Re: 25-26-21MO - Del Sol Turf Installation – Addendum #3

TO ALL BIDDERS:

7 REMOTE CONTROL VALVE WITH GATE VALVE
 NTS 328406.13-25

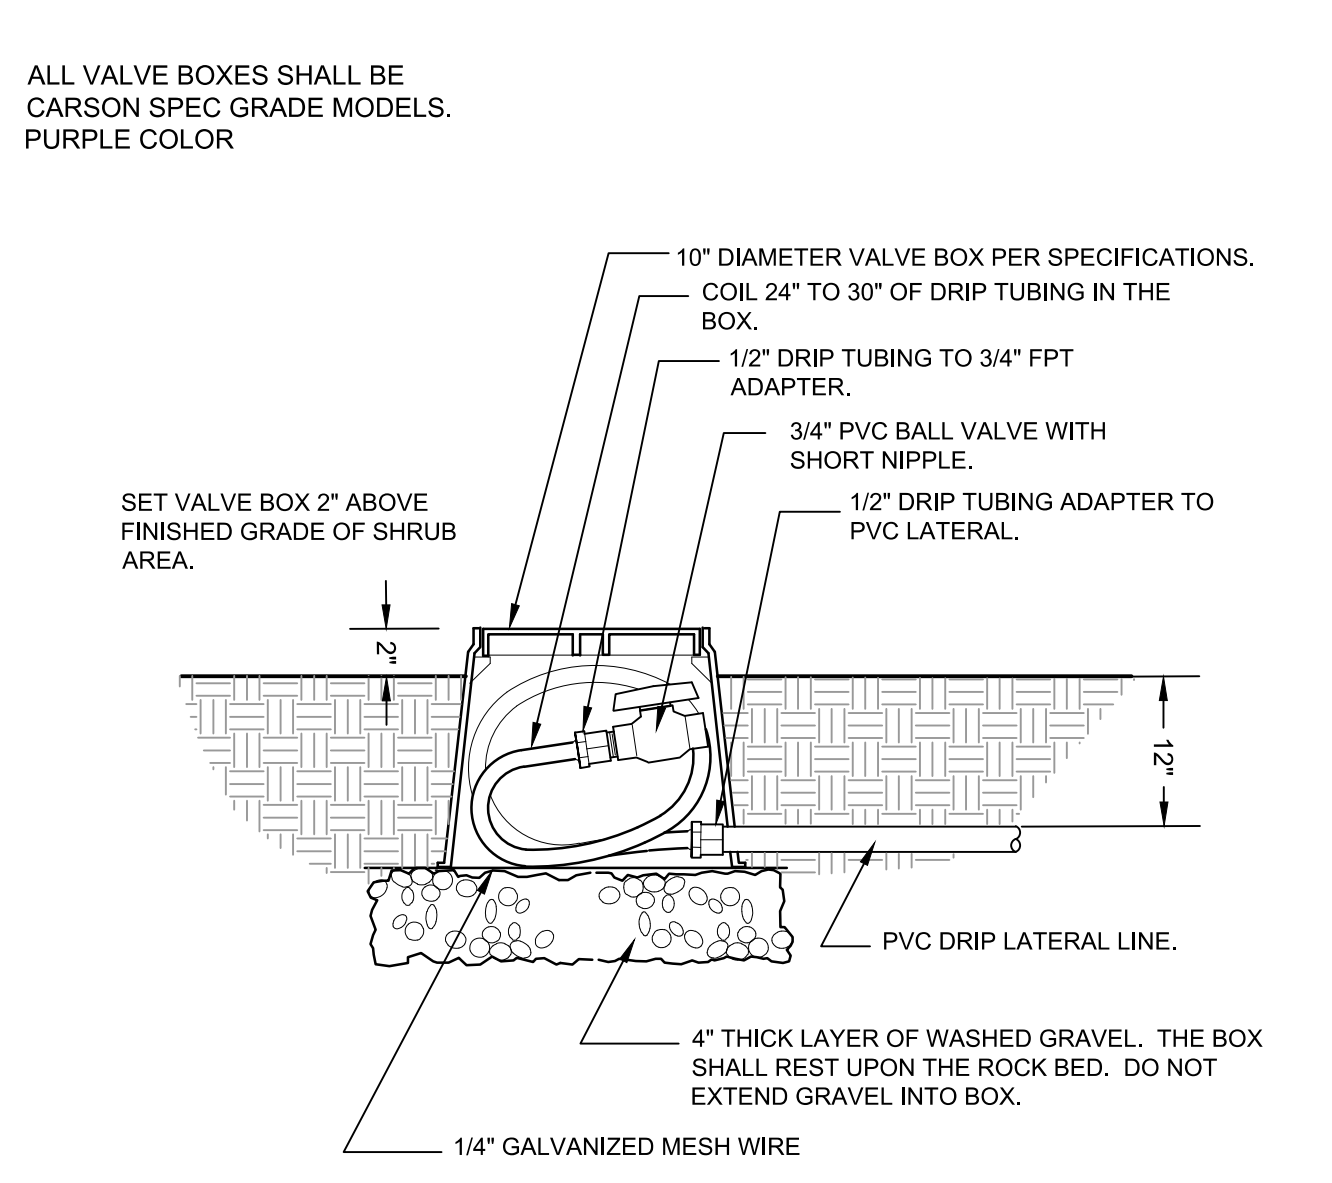
- Answer:** Existing irrigation will be used for this area.
- ITEM #9 **Question:** Scope of work item 1.3 – Irrigation modifications indicate reconnecting existing tree irrigation line to a new dedicated tree irrigation valve. Please confirm that there is existing irrigation mainline for new valve connected to, that is adjacent to the new trees installed.

- Answer:** Irrigation connection will be made to existing valve already controlled by existing irrigation controller. Existing valve will need to be replaced with drip configuration for trees. Please refer to RCV Details.

DRAWING NUMBER: **A1.2**

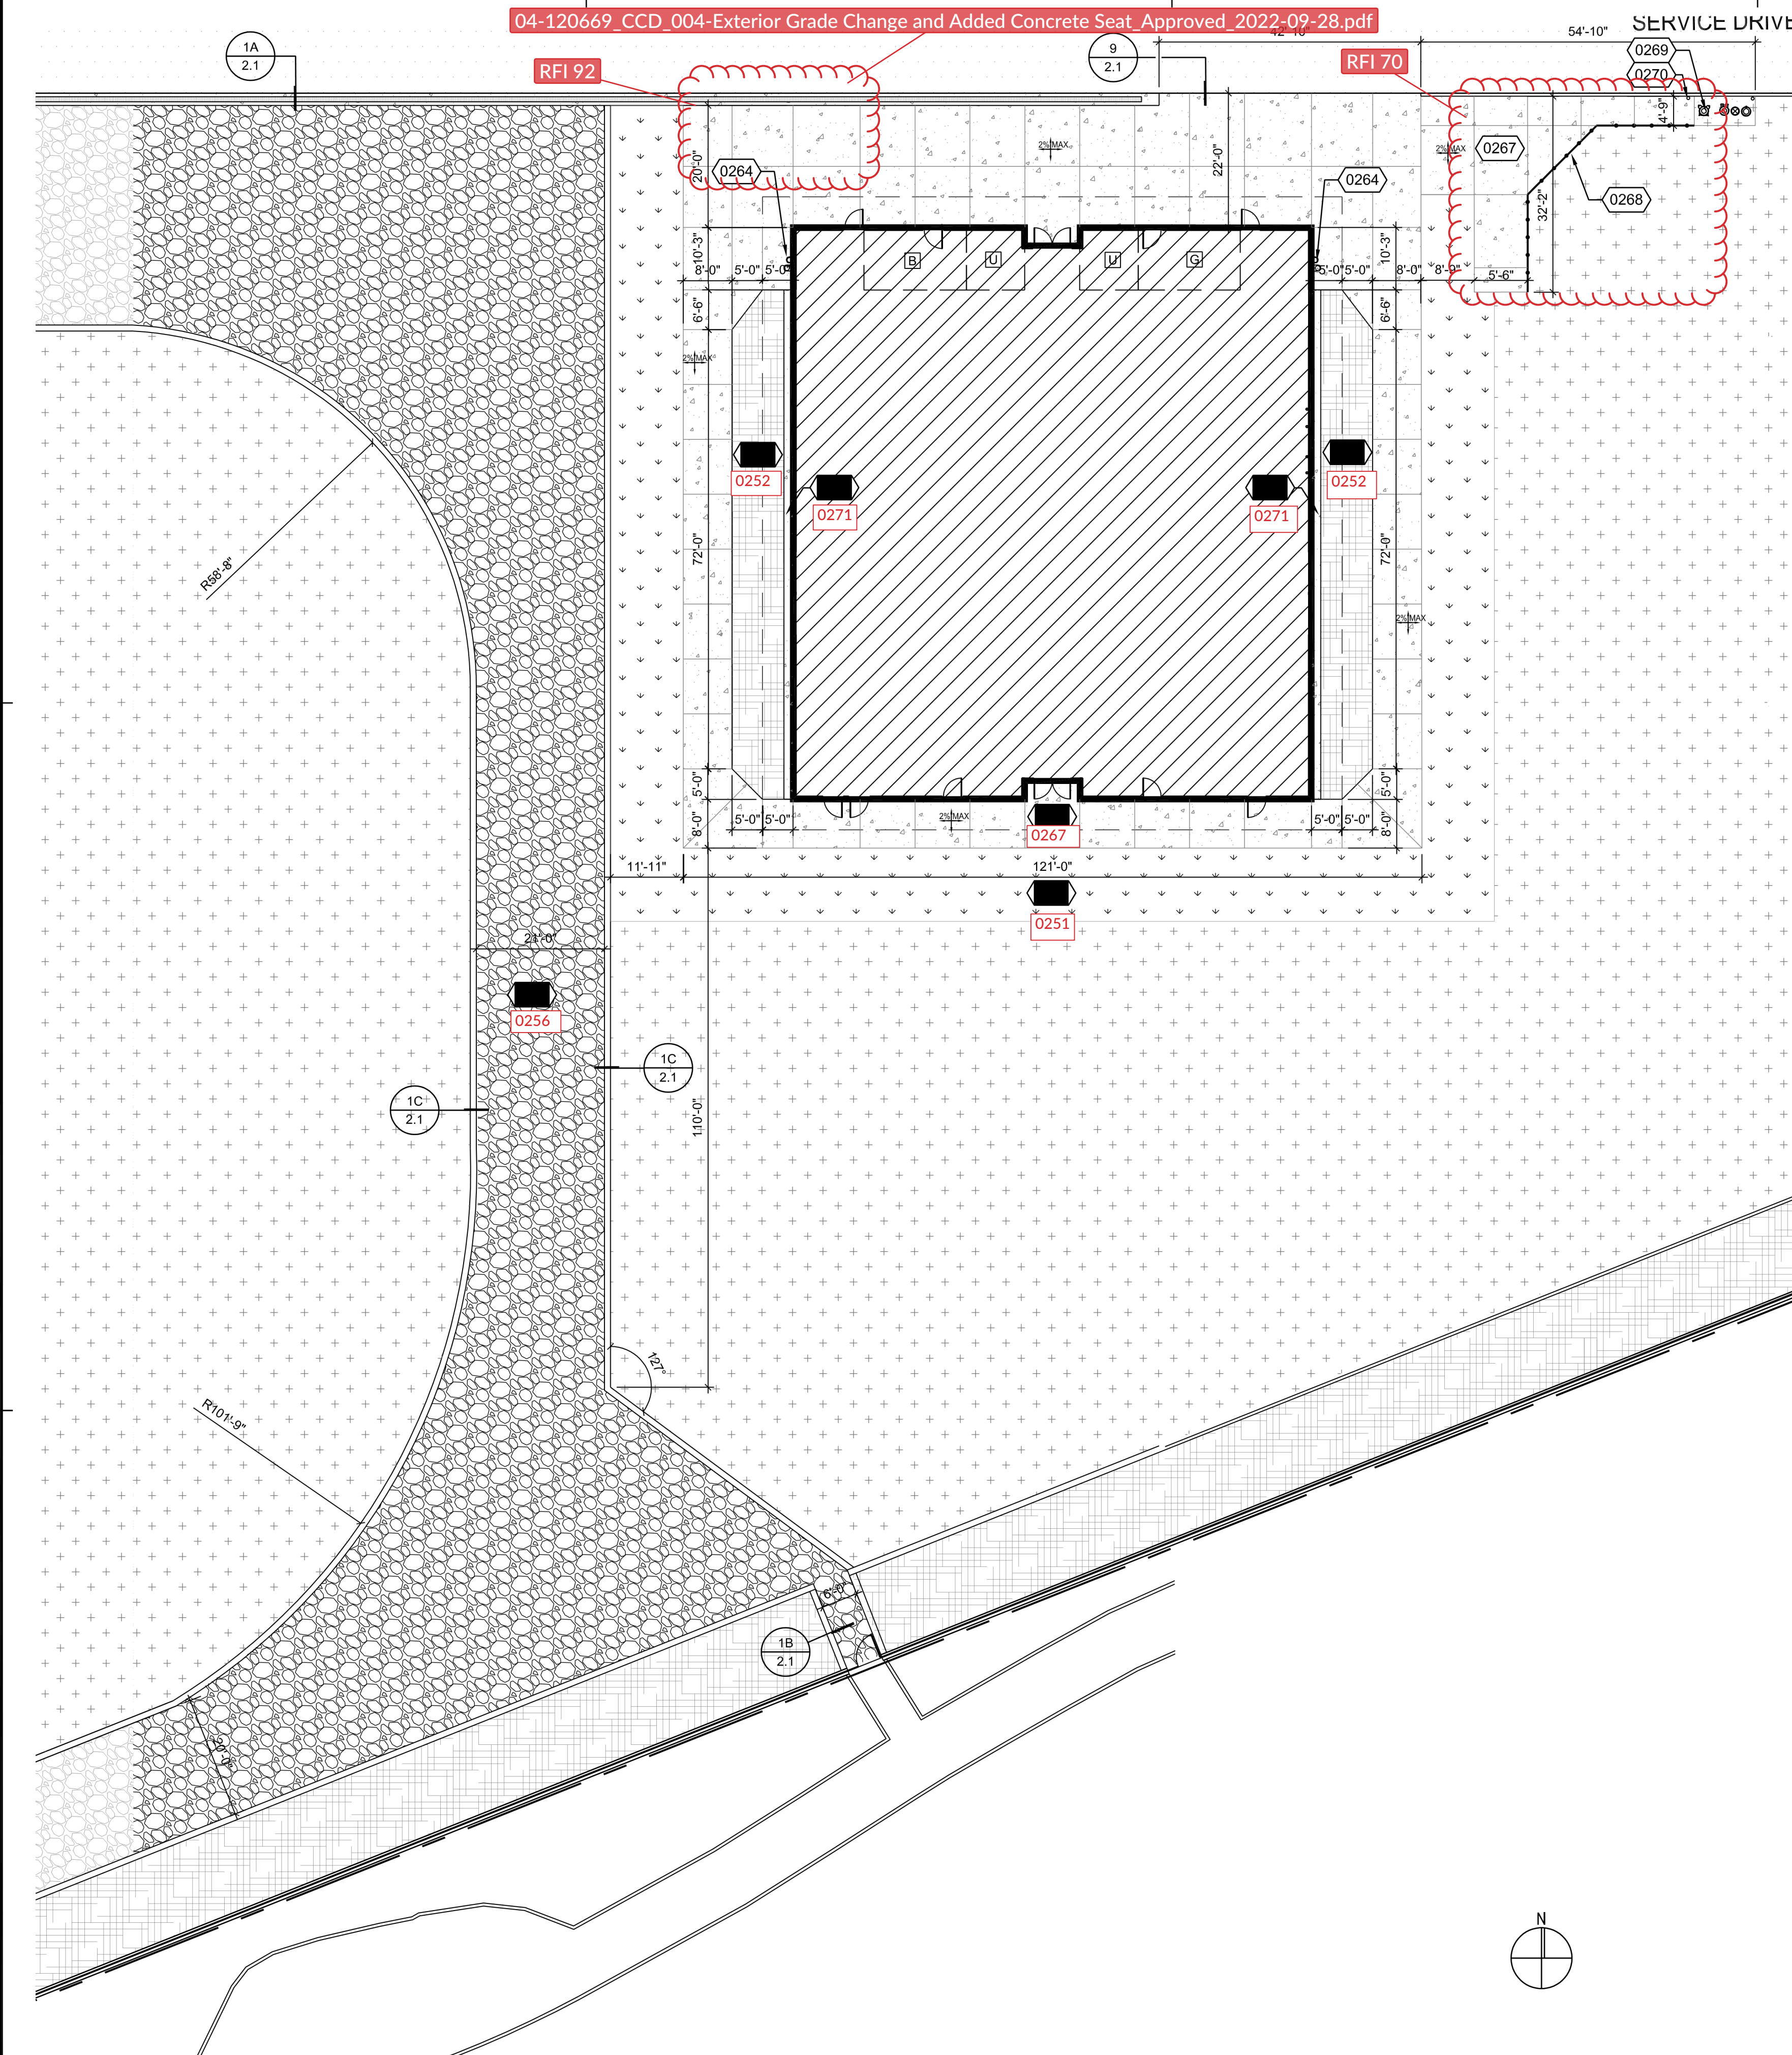
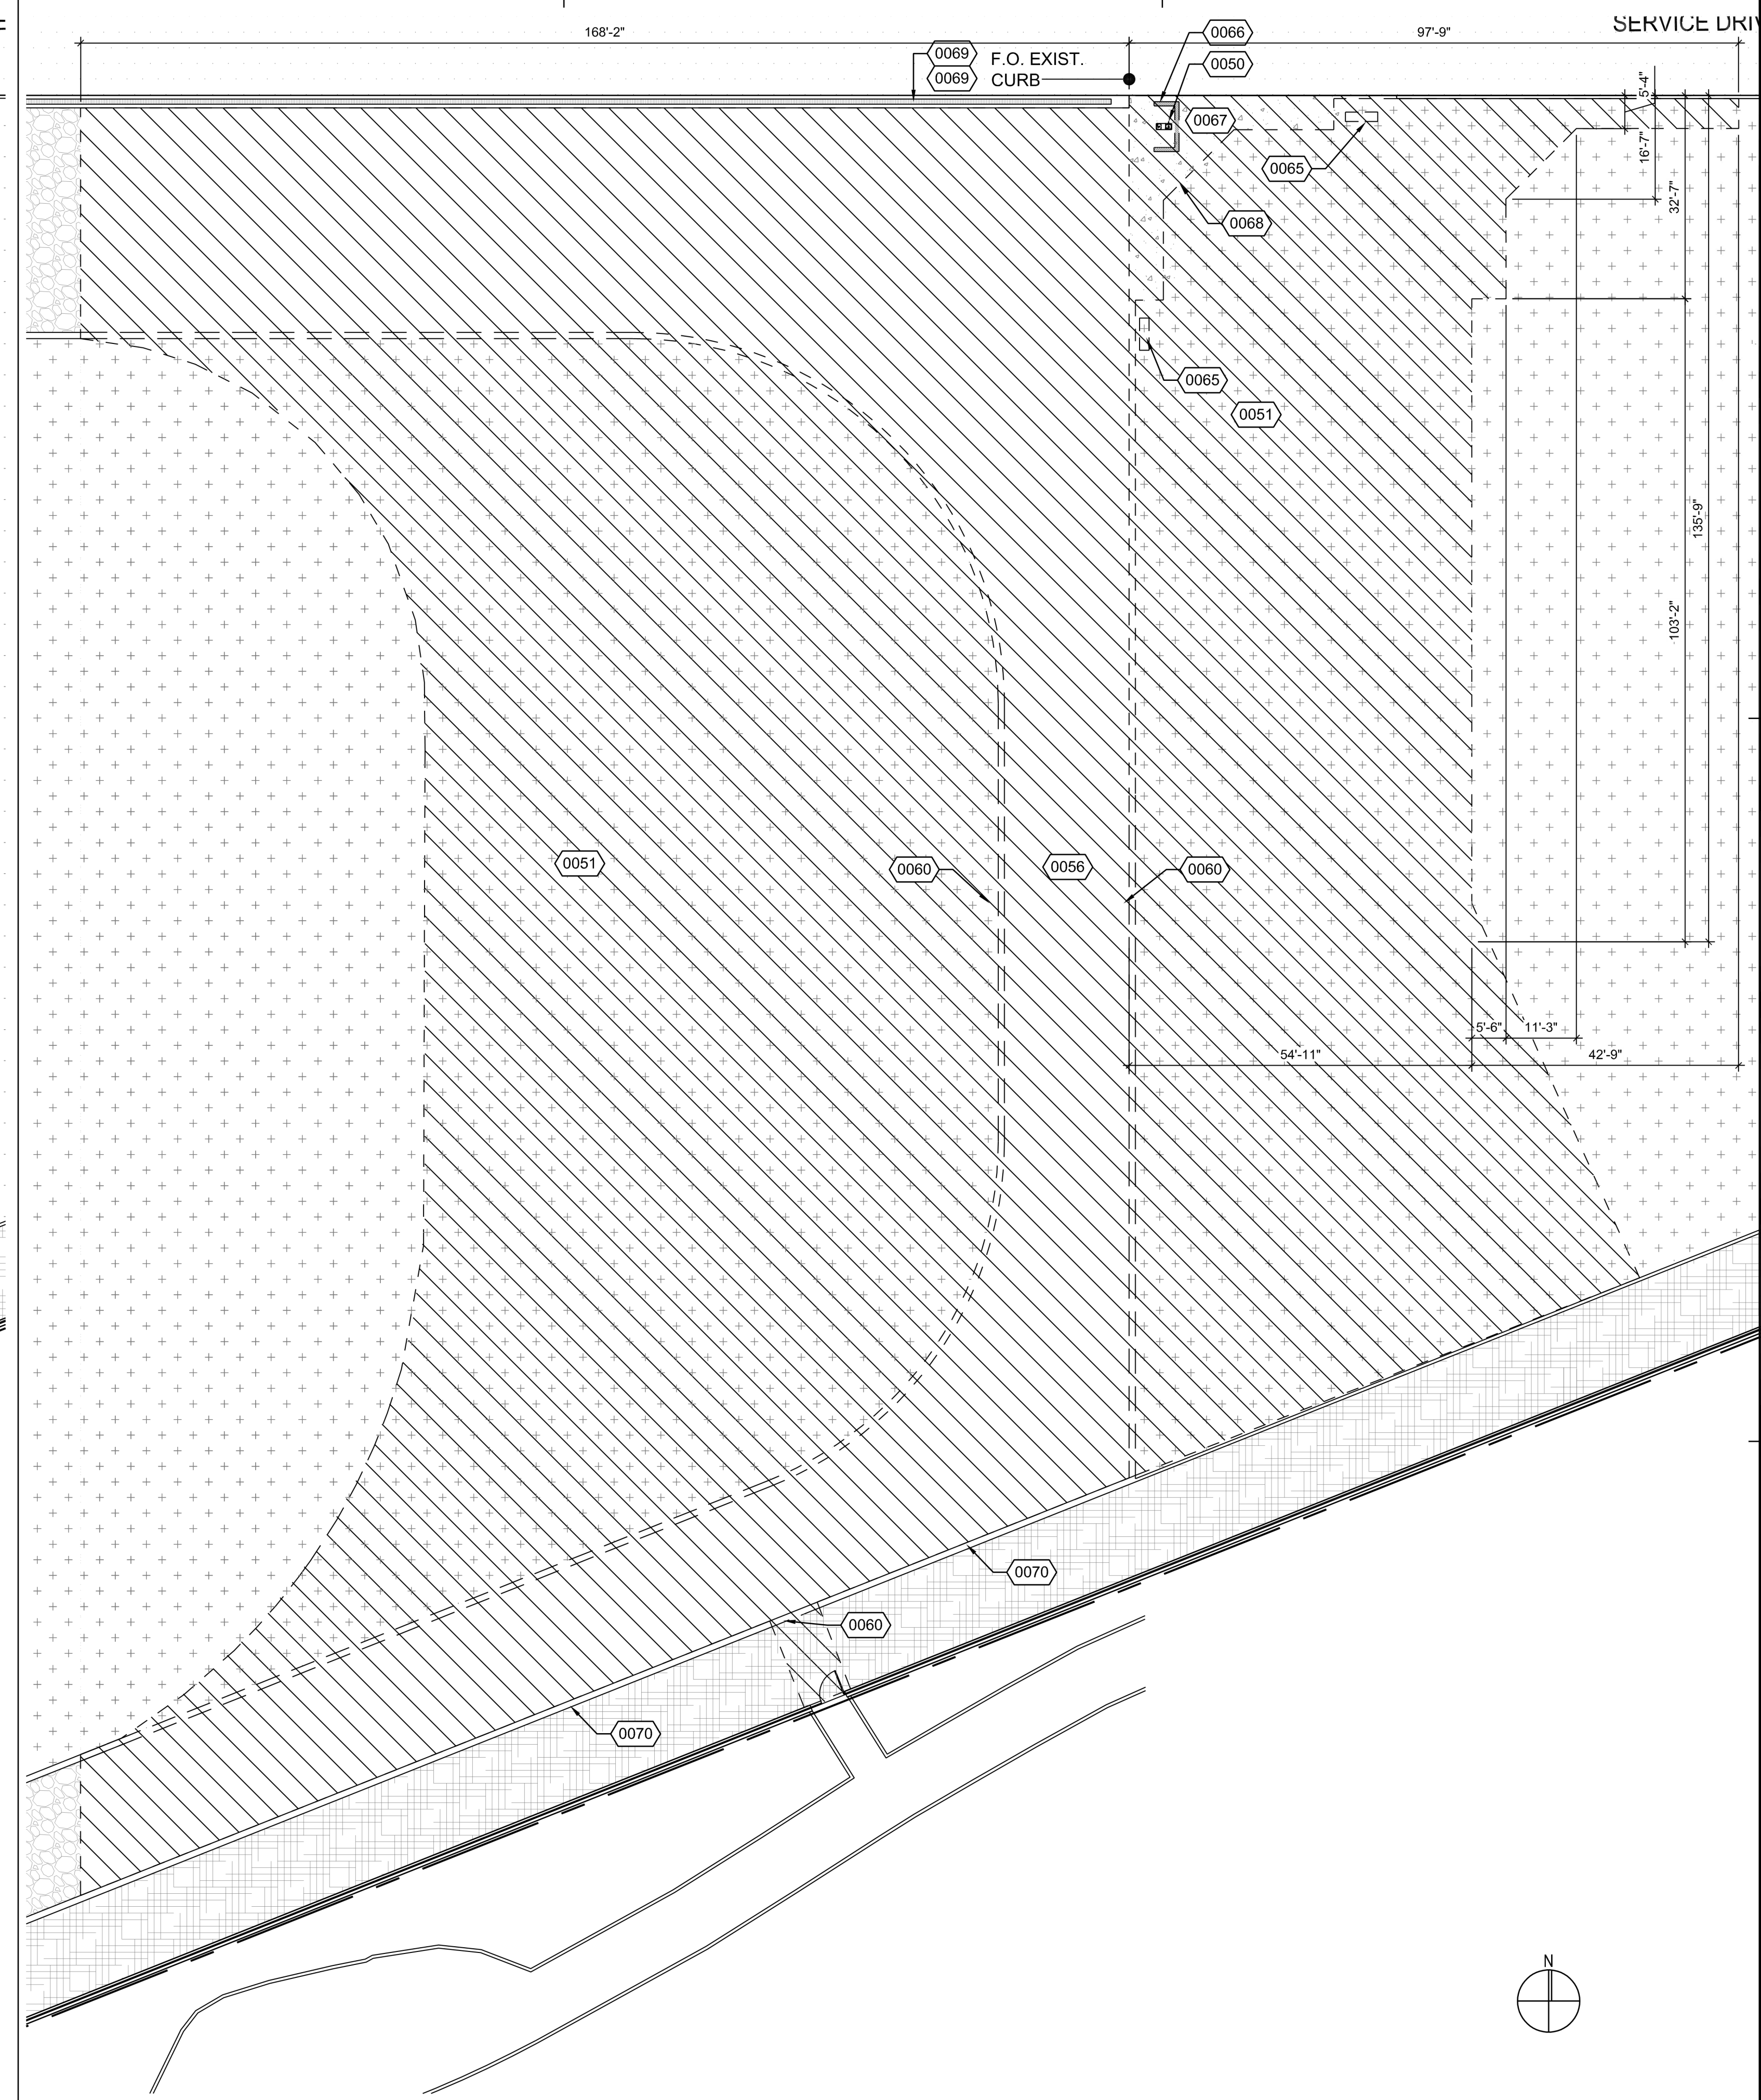
- ITEM #19 **Question:** Please provide sheet A1.2 for enlarged plans as mentioned in Plan Notes #1 on sheet A1.1.
- Answer:** Please see attached
- ITEM #20 **Question:** Please confirm the anticipated start date of the project.

1212 TOP SECTION (WITH GALVANIZED FRAME)

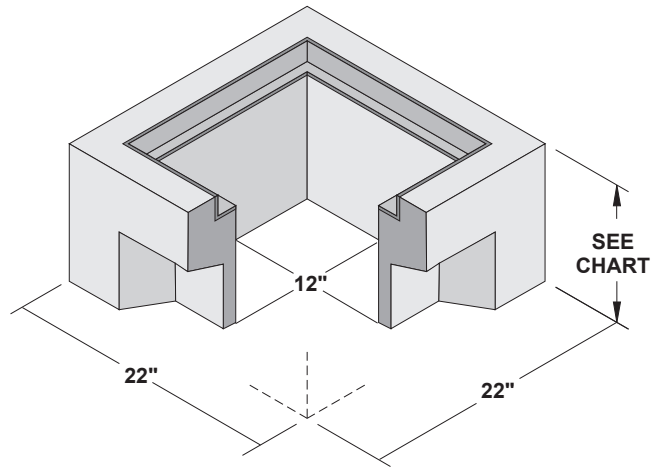
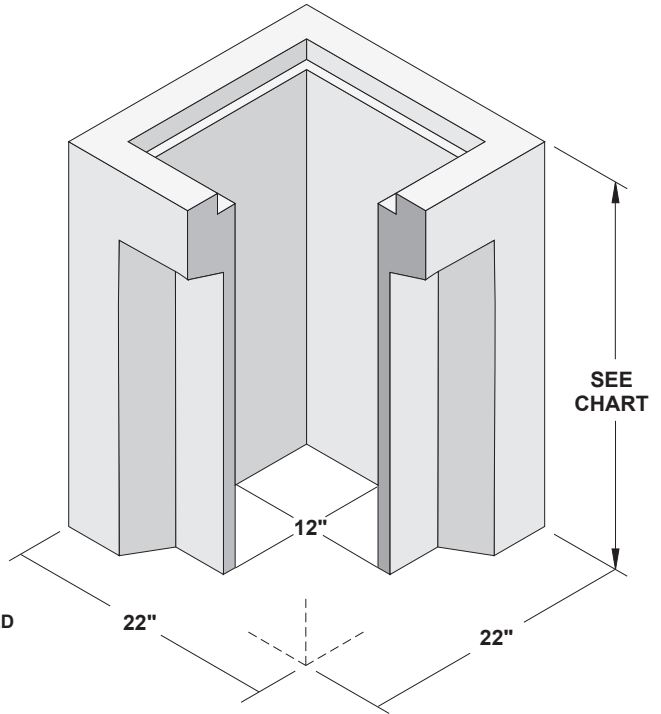
- Answer:** PVC Schedule 40
- ITEM #15 **Question:** Please provide the manufacturer or model of 12" x 12" concrete catch basins as required in scope of work item 5.

- Answer:** Brooks 1212CB
- ITEM #16 **Question:** Please confirm that excavated material can be used for backfilling of storm drainpipe installation.
- Answer:** Yes, excavated materials can be used for back filling.
